TITLE: 2015~2023 Z H2, Z H2 SE, NINJA H2™, NINJA H2™R, NINJA H2™SX, NINJA H2™ CARBON, NINJA H2™SX SE & NINJA H2™SX SE+ CAMSHAFT CHAIN TENSIONER REPLACEMENT

RECALL

Subject

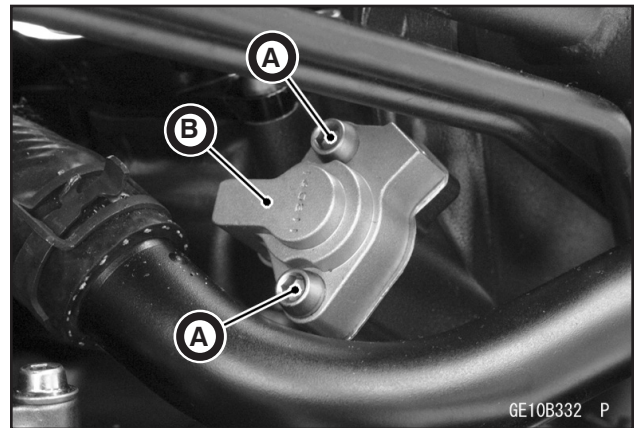
- Remove and retain camshaft chain tensioner mounting bolts [A].
- Remove and discard camshaft chain tensioner [B].

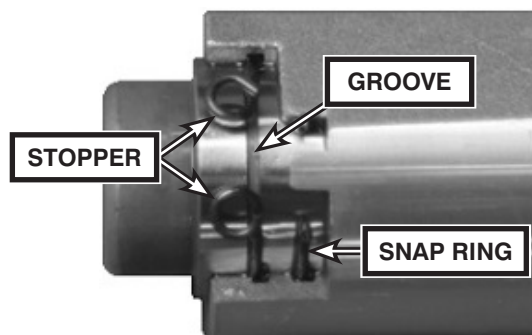
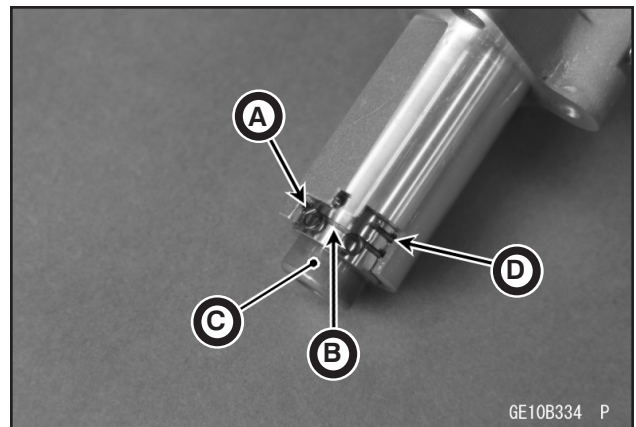
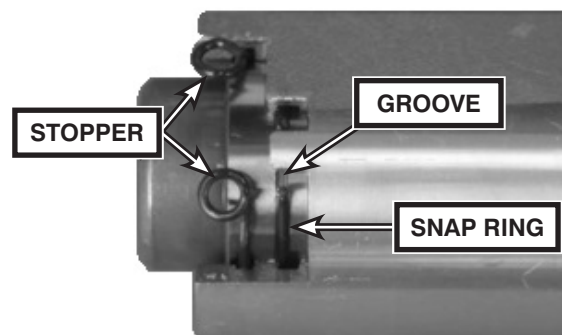
- Verify that stopper [A] is in groove [B] of push rod [C] before installing the tensioner.

- o Be careful not to fit the snap ring [D] into the groove [B] (see images below).

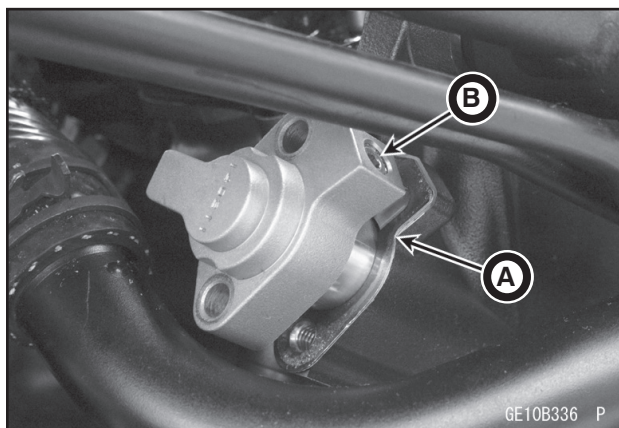
- Replace the gasket [A] with the new one from the repair kit.
- Install the tensioner so that the plug [B] faces upward.
- Tighten the camshaft chain tensioner mounting bolts to 89 in·lb (1.0 kgf·m, 10 N·m).

- o *When installing the tensioner, if the bolts don't engage the cylinder head, the cam timing may be off. Remove the tensioner and check the cam timing then repeat the cam chain tensioner installation.*
